UNITED STATES PATENT AND TRADEMARK OFFICE

APPLICATION NO.	FILING DATE	FIRST NAMED INVENTOR	ATTORNEY DOCKET NO.	CONFIRMATION NO.
10/585,776	07/11/2006	Vitaly Ivanovich Kozhuev	1752	7849
33055	7590	12/26/2007	EXAMINER	
PATENT, COPYRIGHT & TRADEMARK LAW GROUP			FERGUSON, MICHAEL P	
PO BOX 506			ART UNIT	PAPER NUMBER
RICHFIELD, OH 44286			3679	
MAIL DATE		DELIVERY MODE		
12/26/2007		PAPER

Office Action Summary	Application No.	Applicant(s)	
	10/585,776	KOZHUEV, VITALY IVANOVICH	
	Examiner	Art Unit	
	Michael P. Ferguson	3679

DETAILED ACTION

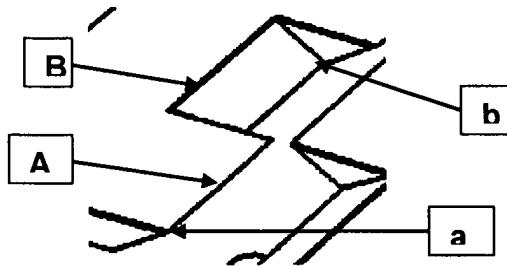
As to claims 1 and 2, Hunting Engineering discloses a joint for flat rigid parts **10,11**, the joint comprising projections **A** (Figure 2 reprinted below with annotations), which are embodied on mating sides of the parts, and complementary joggles **B**, which are embodied in the form of slots **B** corresponding to the projections, characterized in that the surfaces of the edges of the projection and the surfaces of bottoms of the slots mating therewith are embodied in the form of angled surfaces (such angled surfaces constitute conical surfaces, when projections **A** and slots **B** are modified to have concave cross-sections) wherein the peaks **a,b** of the angled surfaces of the projection edges and of the slot bottoms of each part are arranged on opposite sides with respect to a plane of each respective part (point of maximum width **a** of projection **A** constitutes

a peak **a**; point of maximum depth **b** of slot **B** constitutes a peak **b**; such peaks **a,b** are arranged on opposite sides of plates 10,11; Figure 2).

As to claim 6, Hunting Engineering discloses a joint wherein the surfaces of the edges of the projections **A** and the surfaces of the bottoms of the slots **B** mating therewith each comprise angled surfaces having a guiding line on an angled surface that passes through a peak **a,b** (such angled surfaces constitute conical surfaces, when projections **A** and slots **B** are modified to have concave cross-sections), and wherein the guiding lines and the peaks of the projection edges and the slot bottoms of each part **10,11** are arranged on opposite sides with respect to a plane of each respective part (point of maximum width **a** of projection **A** constitutes a peak **a**; point of maximum depth **b** of slot **B** constitutes a peak **b**; such peaks **a,b** are arranged on opposite sides of plates **10,11**; Figure 2).

As to claim 7, Hunting Engineering discloses a joint wherein a radius of curvature **R** of the guiding lines of the angled surfaces is equal to the radius of curvature of the slot **B** within the accuracy of the value of the gap between the parts **10,11** (Figure 3).
